**Re: Water Treatment Plant – Construction Contingency Expense No. 6**

**Re: Ramsey Water Treatment Plant - Ramsey, MN**

**1 SECTION - PLATE SETTLER ROOM - LOOKING NORTH**  
 P306

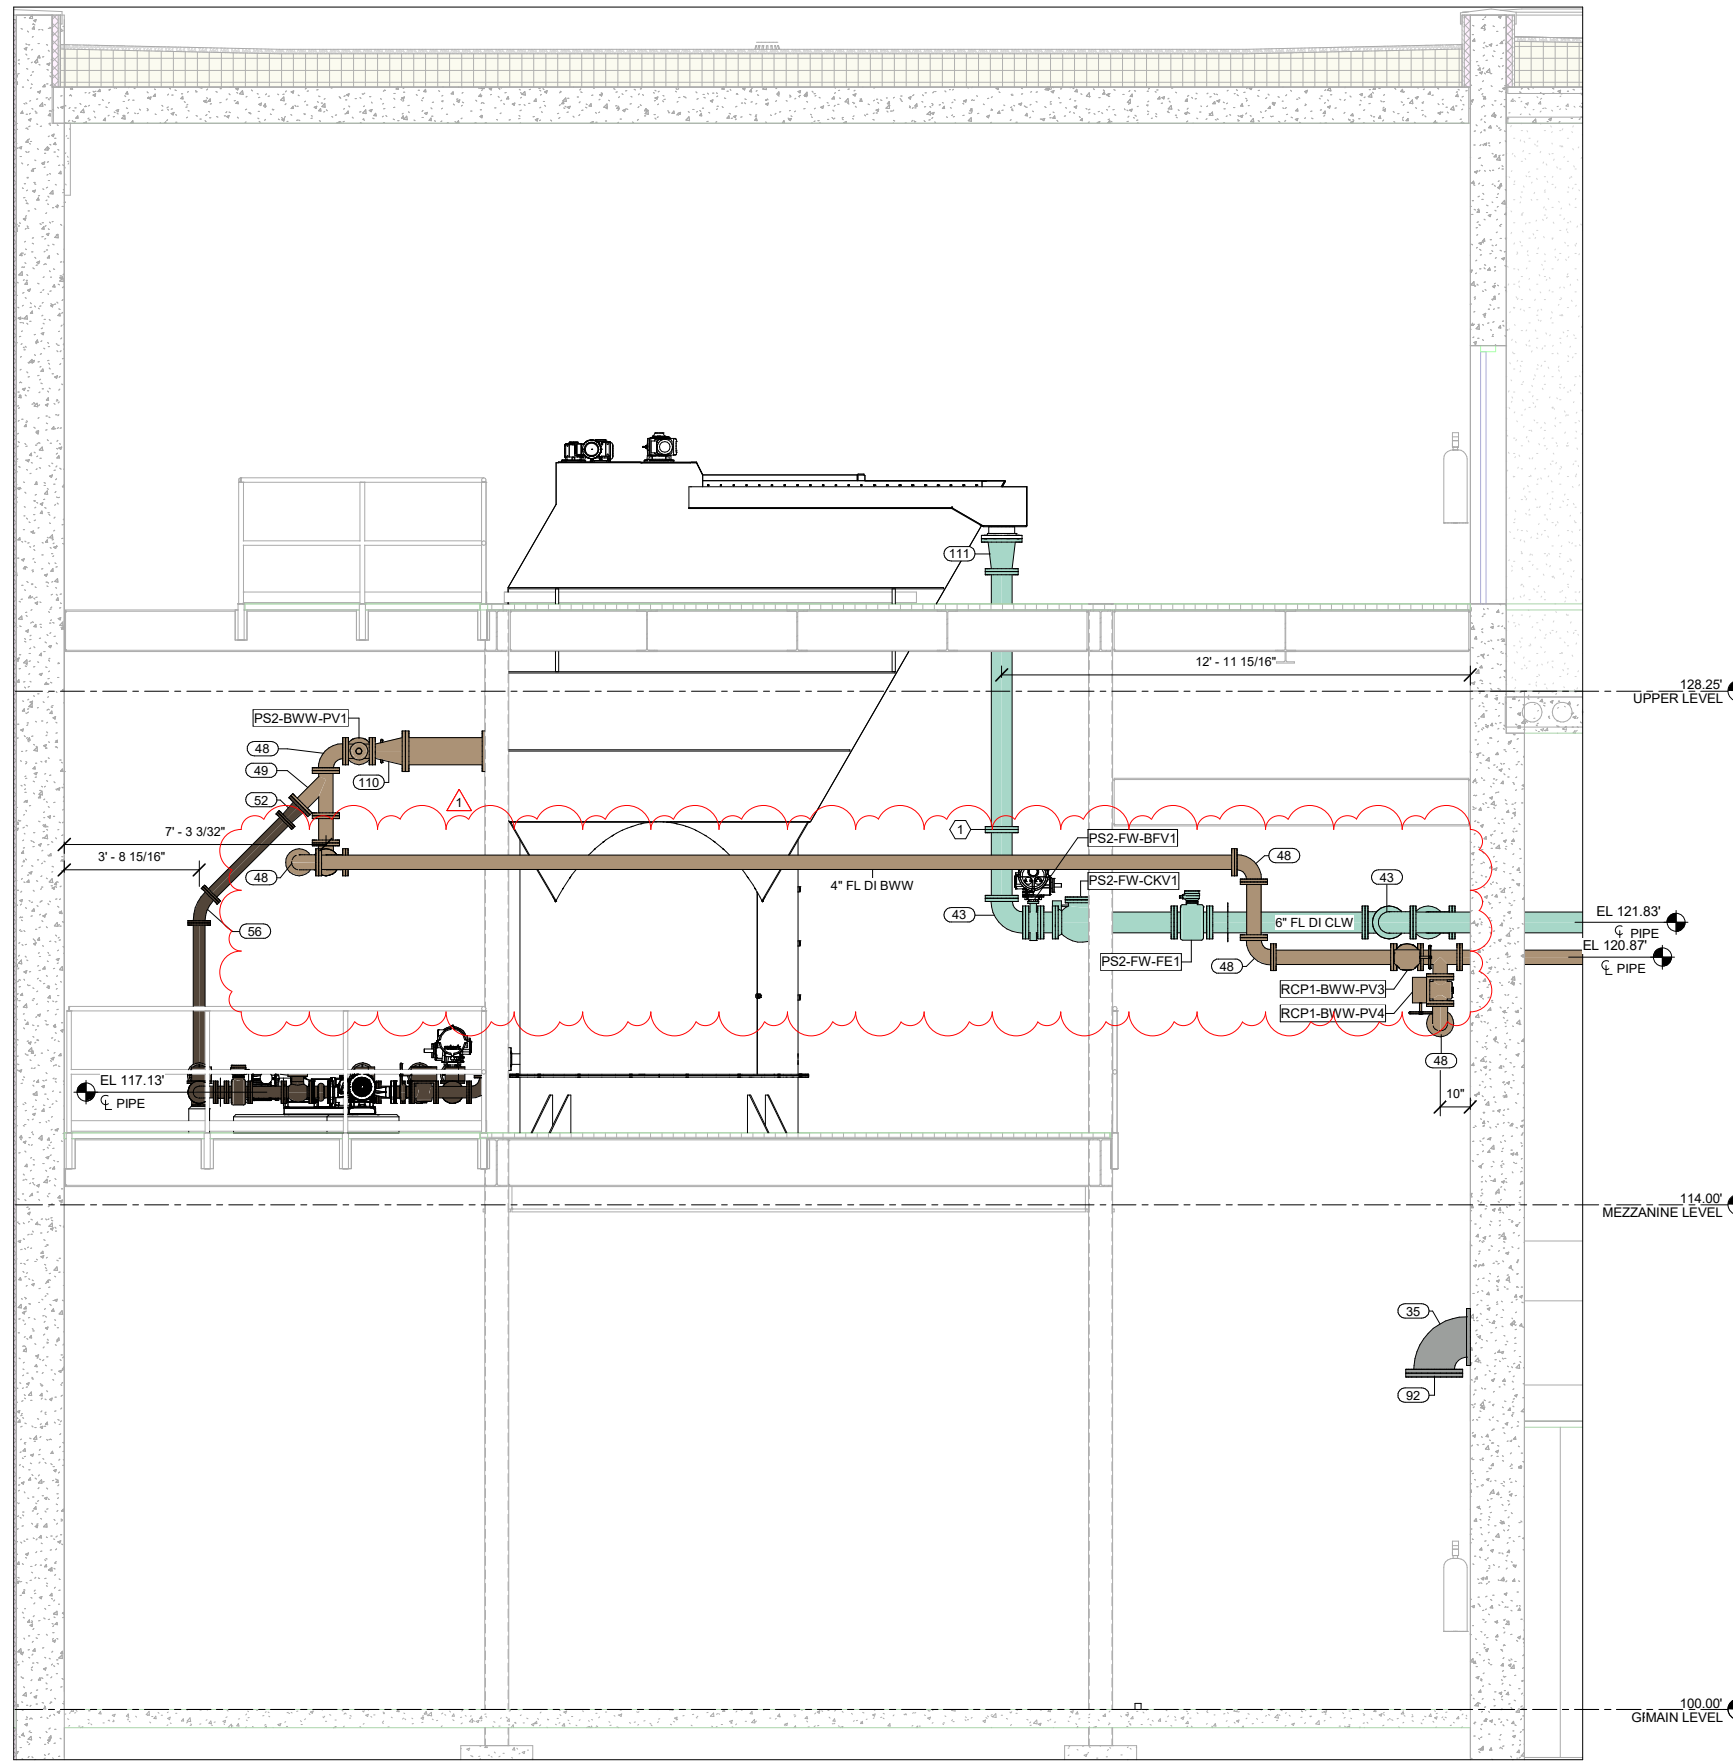
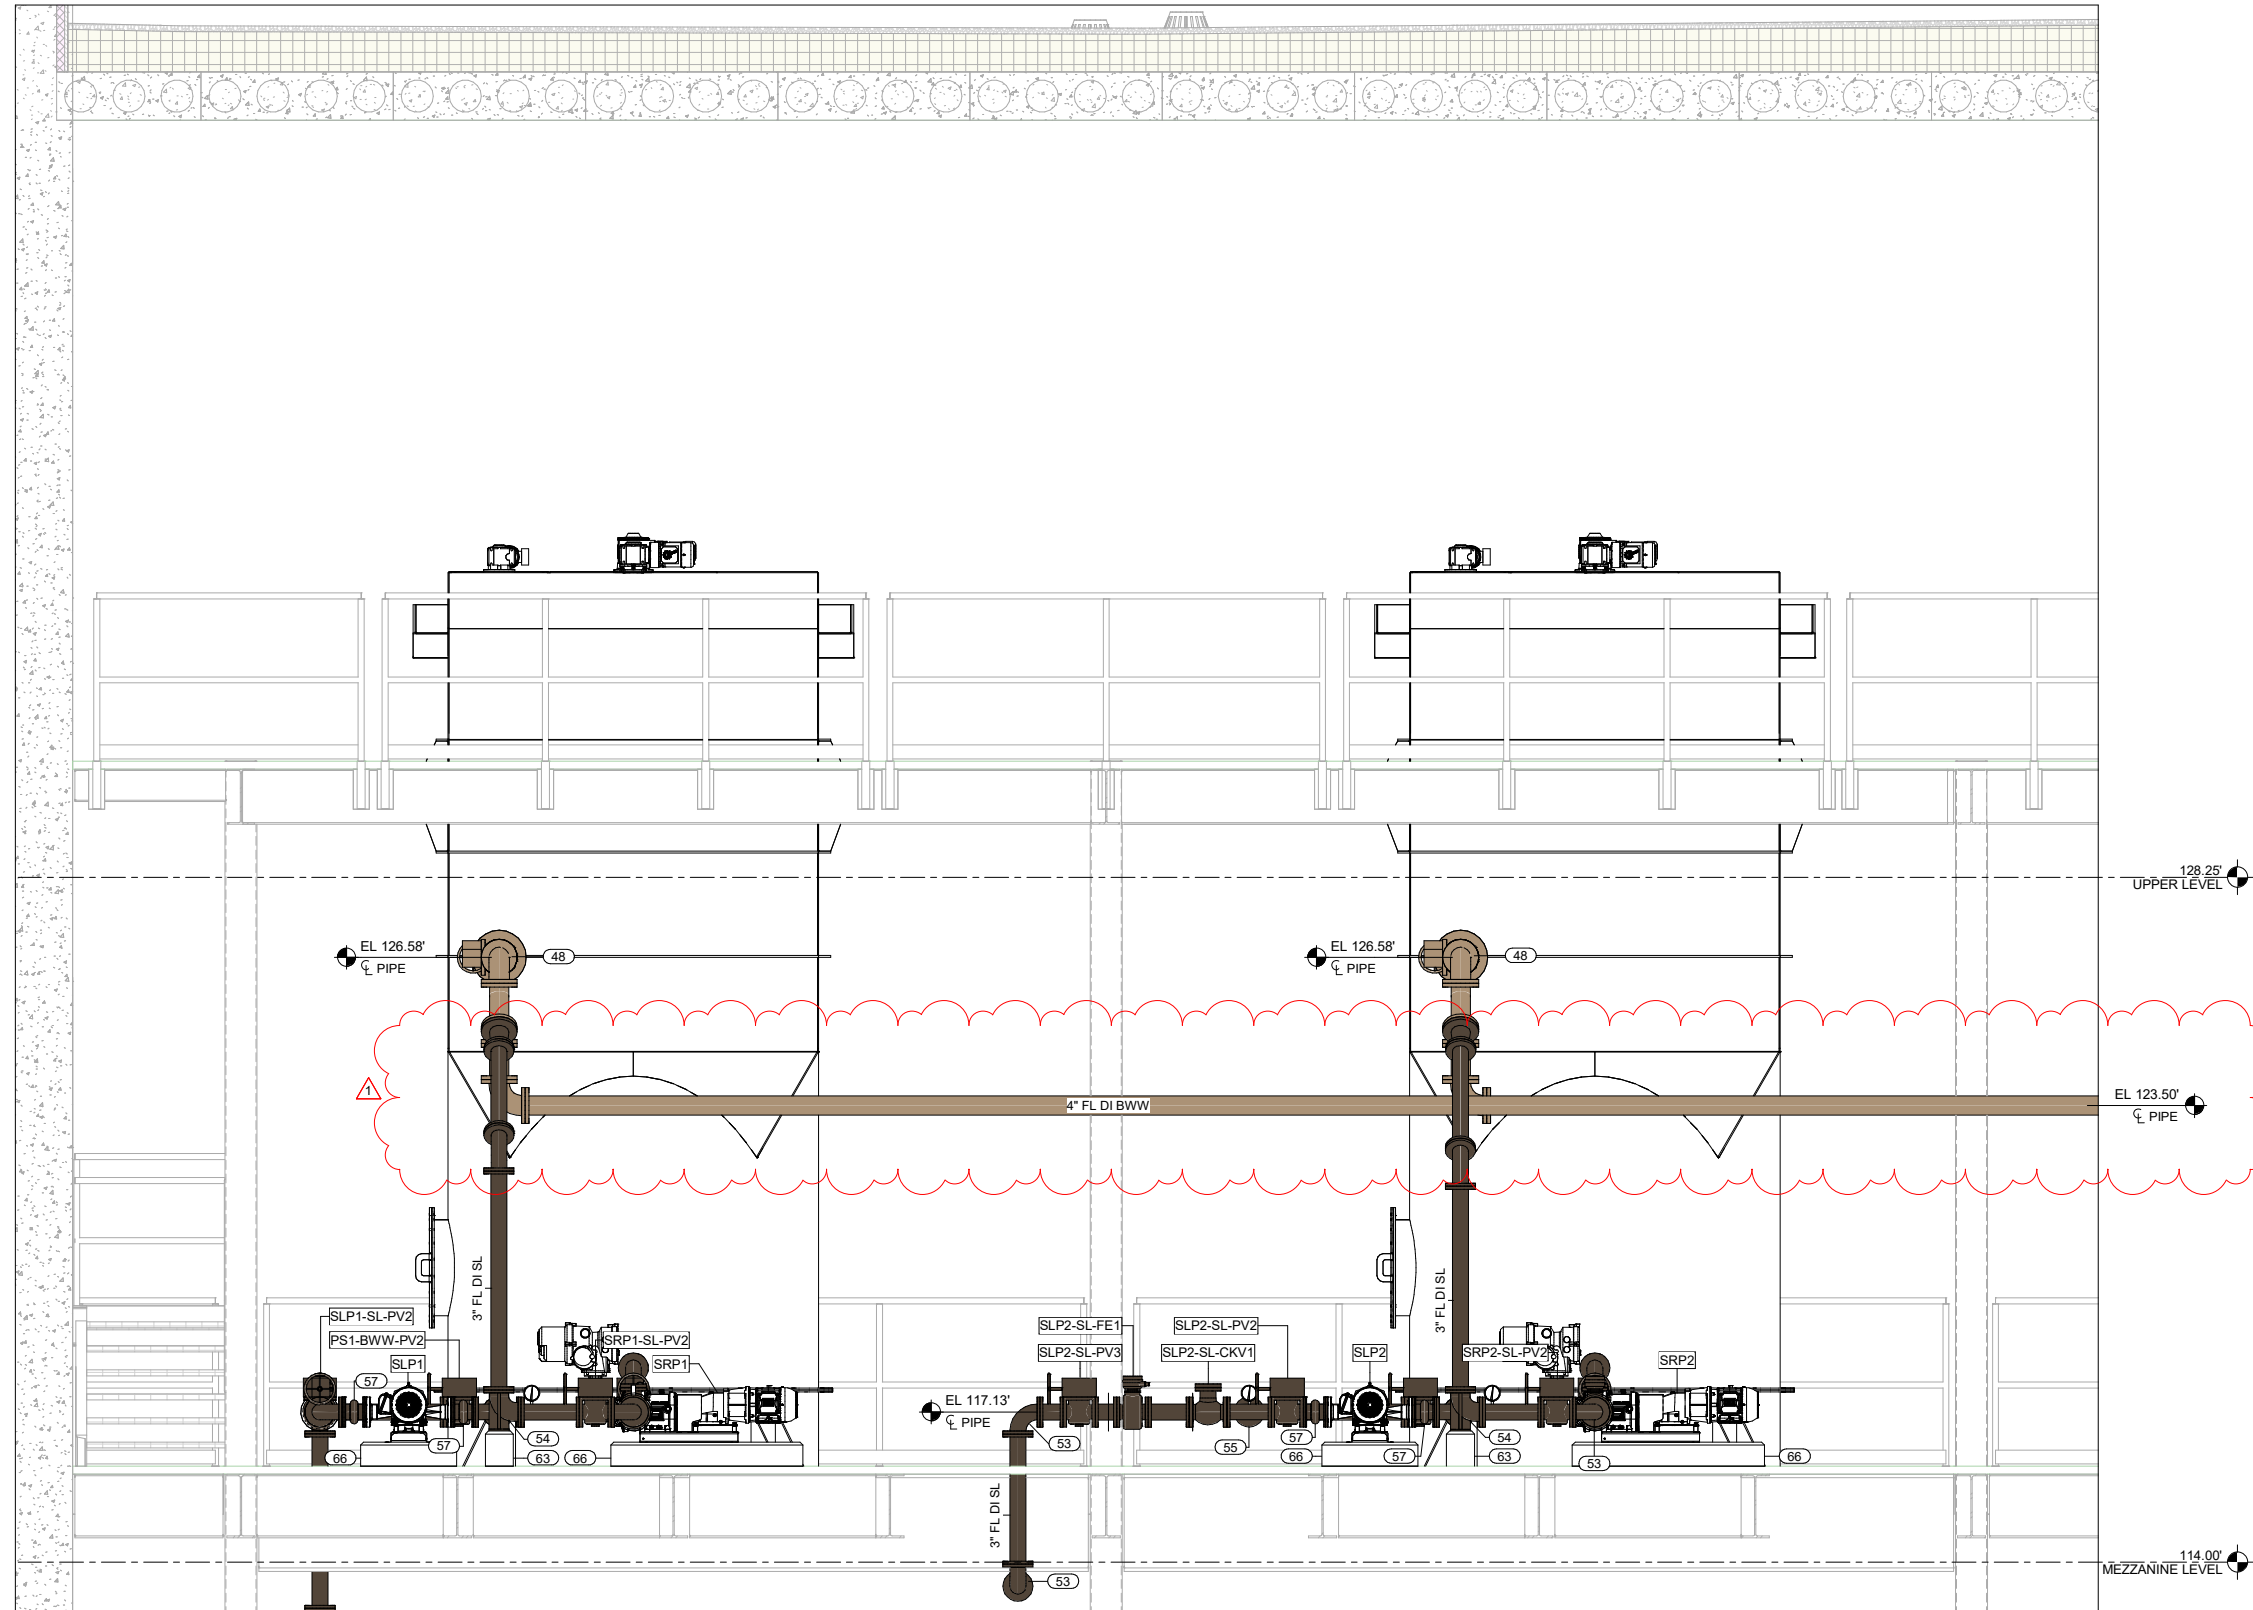
Magney Construction, Inc. is pleased to present the following quotation to provide the necessary labor, material and equipment to Raise the 4" BWW Centerline to an elevation of 123.50' from 120.87', following the route on the revised P306 & P307 piping drawings included with RFP No. 015 BWW Piping Relocation. The costs associated with this change are summarized below.

AE2S requests pricing from Magney for the cost/credit of modifying the backwash waste piping in the plate settler room. At the current designed elevation the backwash waste piping limits accessibility of the room. The elevation needs to be raised to 123.5' to allow a walkway below the piping. See attached drawings.

During construction of the plate settler area, the elevation of the back wash waste pipe in the plate settler room was found to be too low for accessibility. RFP No. 015 showcases new drawings that shift the pipe slightly. Contractor price reflects material and labor.

1 MAIN LEVEL PLUMBING PLAN

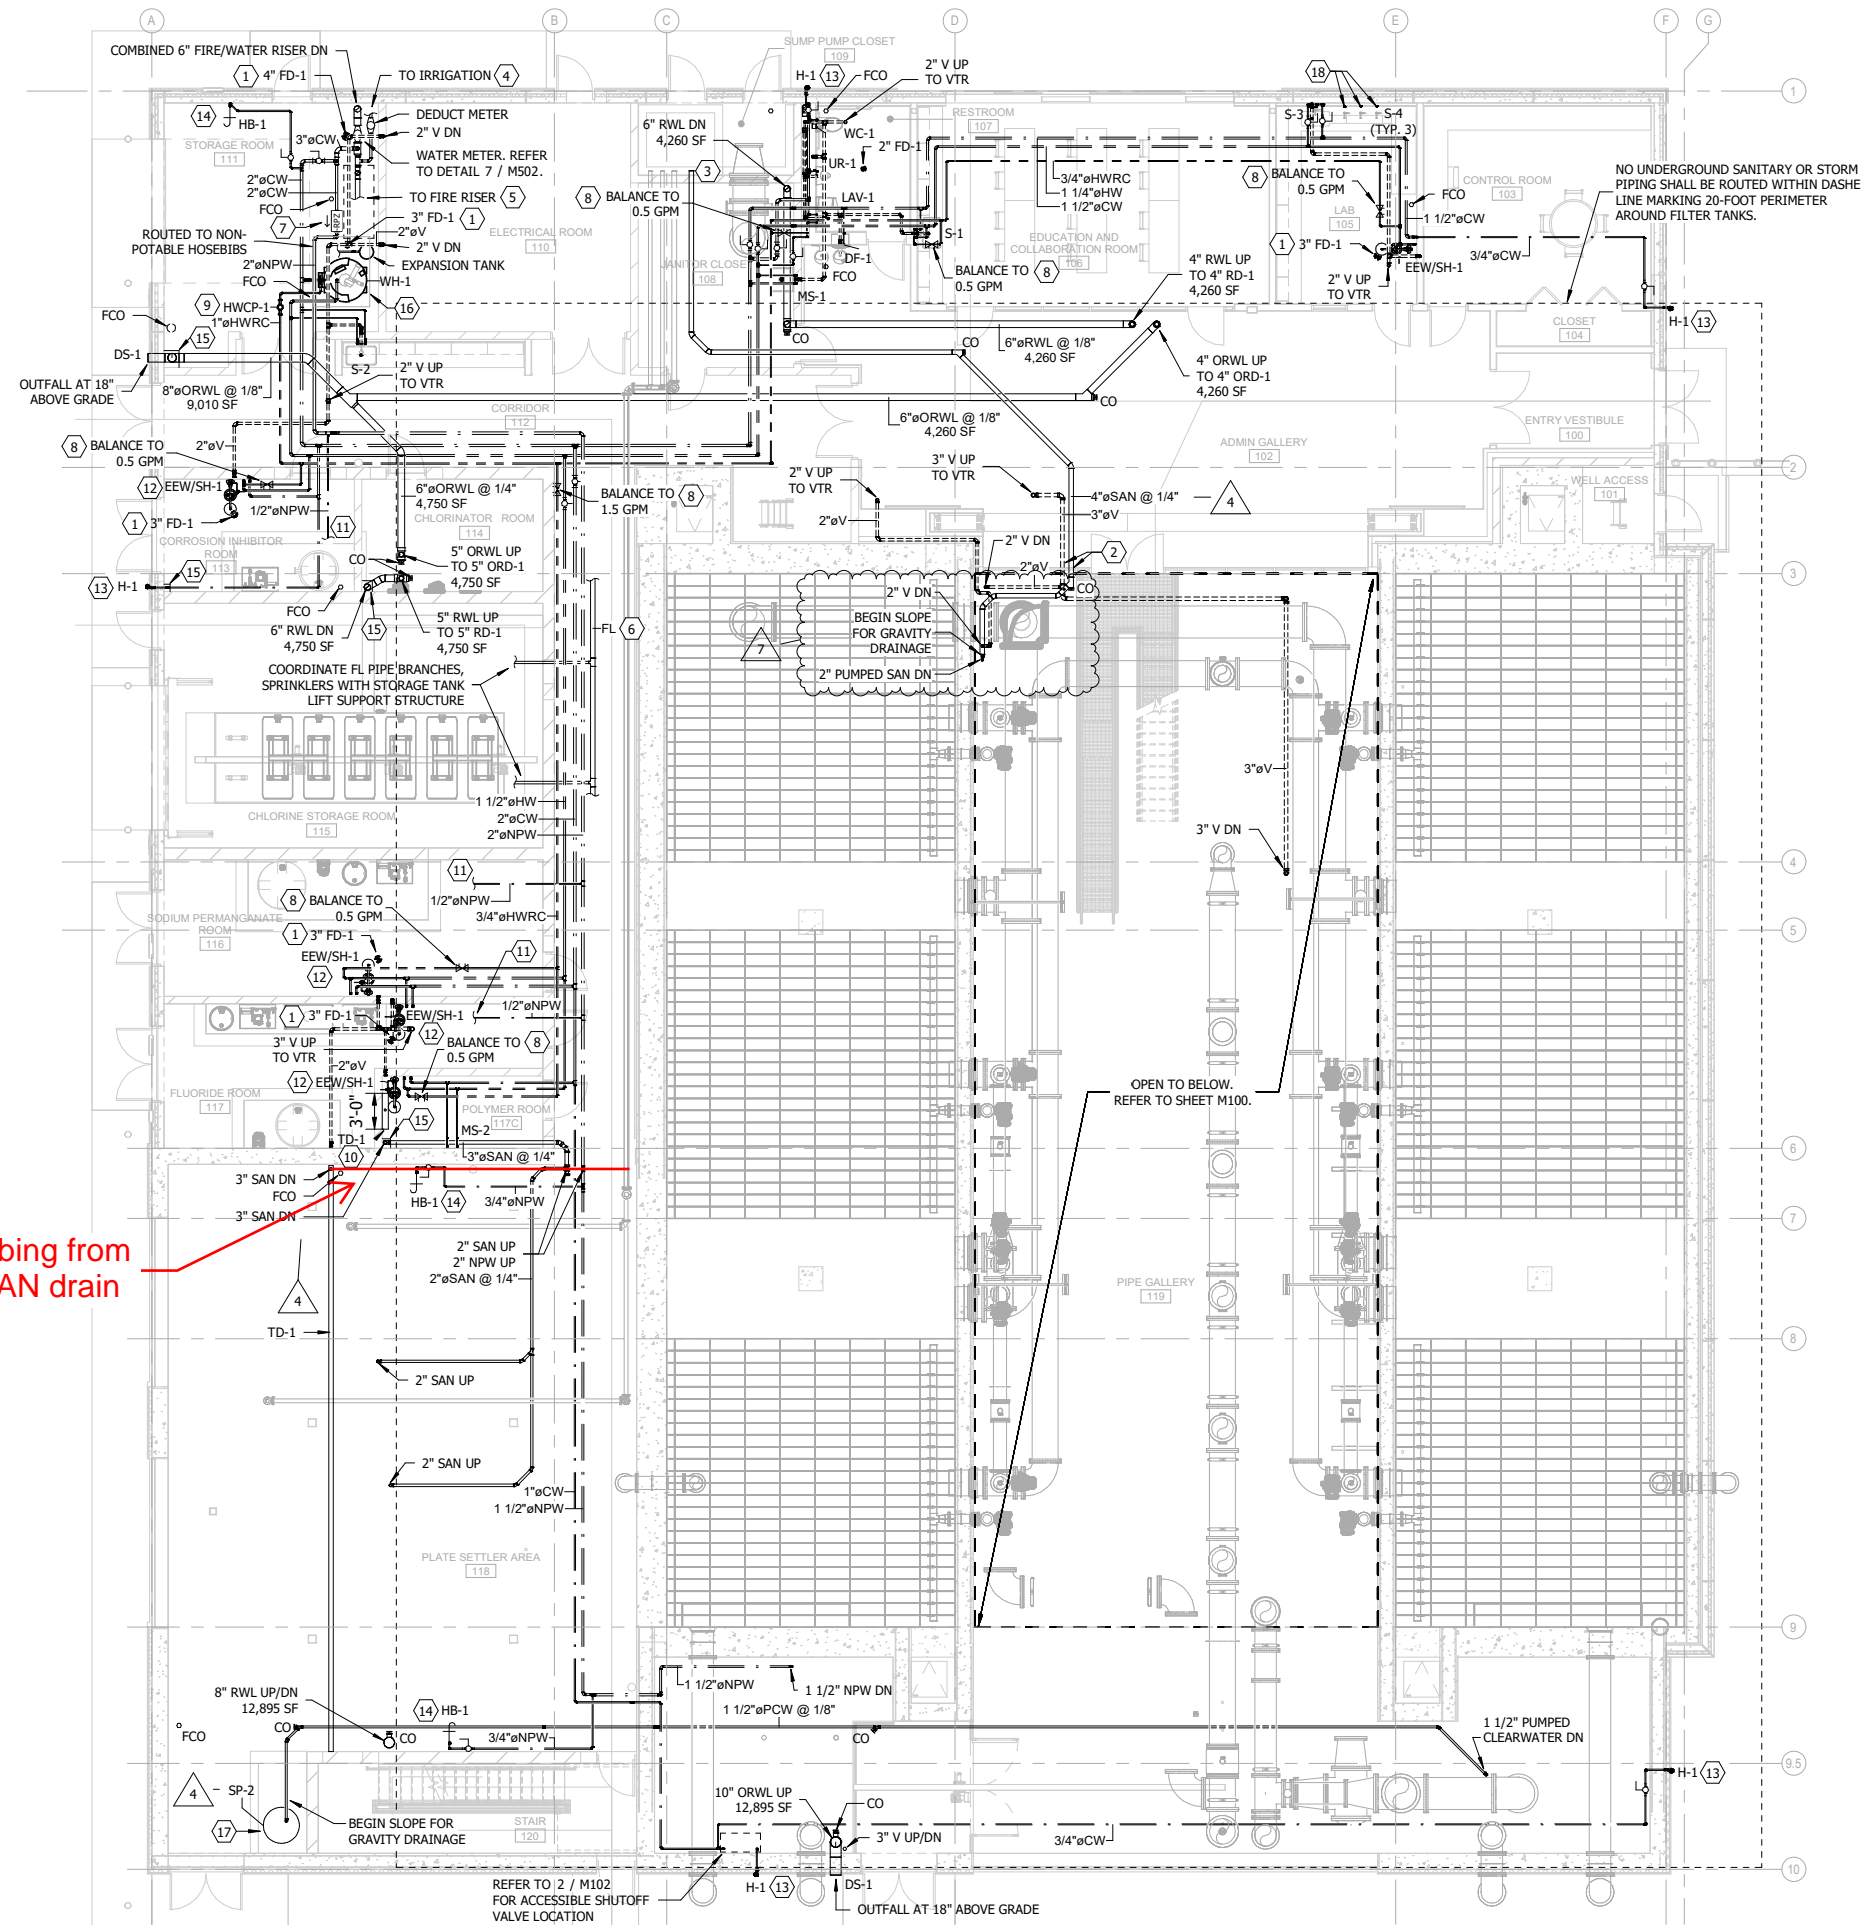
AE2S requests pricing from Magney for the cost/credit to install additional 3" drain piping from the west side of backwash tank water wick to the most convenient sanitary drain.

Run drain plumbing from water wick to SAN drain

Magney Construction, Inc. is pleased to present the following quotation to furnish the necessary labor, material, and equipment needed to complete the changes requested in RFP No. 016 Water Wick Drain Connection. The costs summarized below cover a 3" drain line from the Northeast corner of the Plate Settler room to the sanitary drain on the North end of TD-1 in the Plate Settler room. Please note that this run of piping requires an additional vent line. Please see the costs associated with this change are summarized below.
